Access Compliance Report Public Rights-of-Way (Curb Ramps)

Intersection ID: 9073 Main Street: HUNTERS CROSSING LN **Cross Street: THE PLAZA** Location: NW Initial Pass/Fail: Fail **Overall Compliance: No Severity Score:** 10 ADA ID: 70E5EB1CF7C5 Ramp Type: BlendTrans2

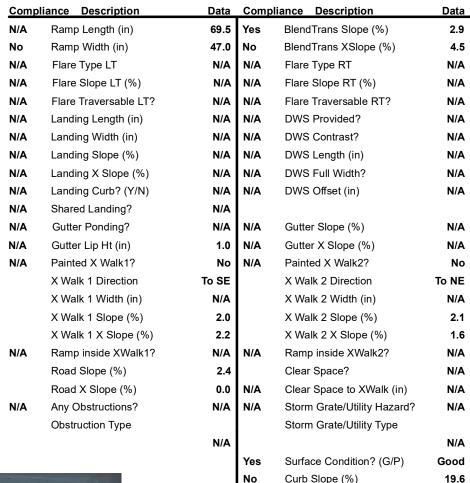
THE PLAZA None **HUNTERS CROSSING LN** StopSign Possible Solutions: Remove & Replace Curb Ramp With Two New Directional Ramps or Equivalent. Surveyor Notes: **NO RT SW** PROW/ADA: Not Found, R304.5.1, R304.5.3
